Intel Technical Advisory

TA-1011-01

I2C CABLE CONNECTION ISSUE WITH INTEL® SERVER SYSTEM P4208CP4MHGC

Figure 3. Cascaded I²C cable connection for two backplanes

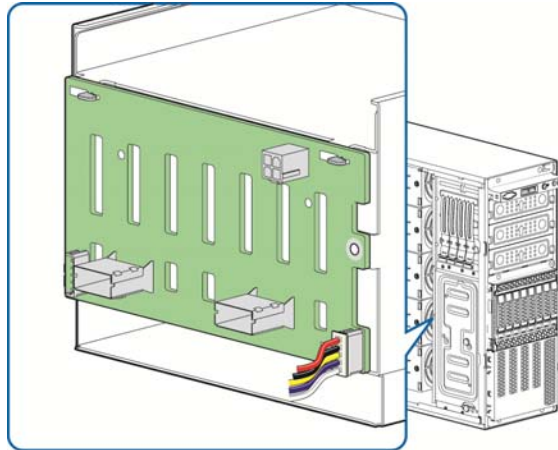
When installing a second backplane in the Intel® Server System P4208CP4MHGC, the two backplanes need to be cascaded with two I²C cables. The first I²C cable should connect to the "I2C_IN" connector on the first backplane, and the second I²C cable should connect from the "I2C_OUT" connector on the first backplane to the "I2C_IN" connector on the second backplane (Figure 3).

Figure 1. I²C cable is connected to the "I2C_OUT" connector

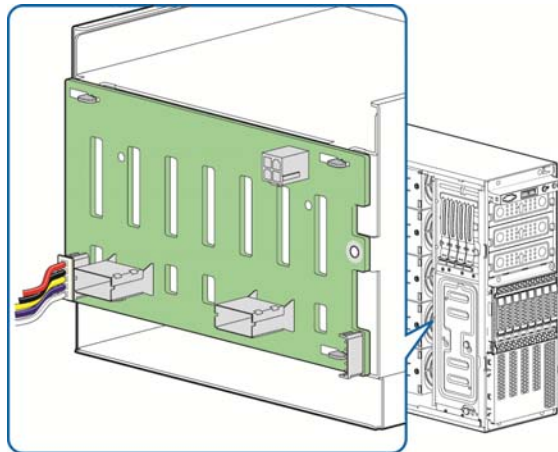
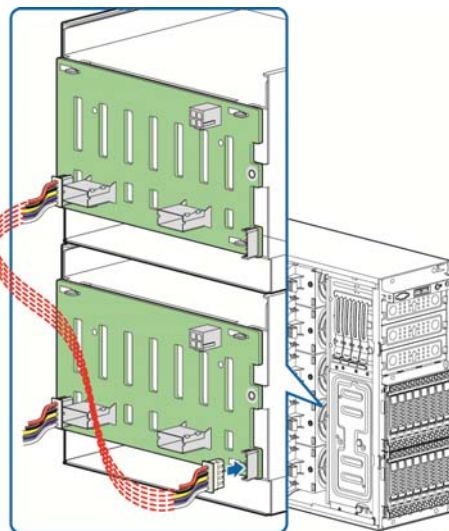
In the Intel® Server System P4208CP4MHGC with the above mentioned Serial Numbers, the I²C cable is connected to the connector labeled "I2C_OUT" on the backplane (Figure 1). However, to install a second backplane in the system, the I²C cable needs to be connected to the connector labeled "I2C_IN" on the original installed backplane (Figure 2).

Intel is implementing a change in manufacturing to connect the I²C cable to the "I2C_IN" connector on the original backplane in the Intel[®] Server System P4208CP4MHGC, as shown in Figure 2 above.

Customers should connect the I²C cable to the "I2C_IN" connector on the original backplane (Figure 2) in the Intel[®] Server System P4208CP4MHGC.
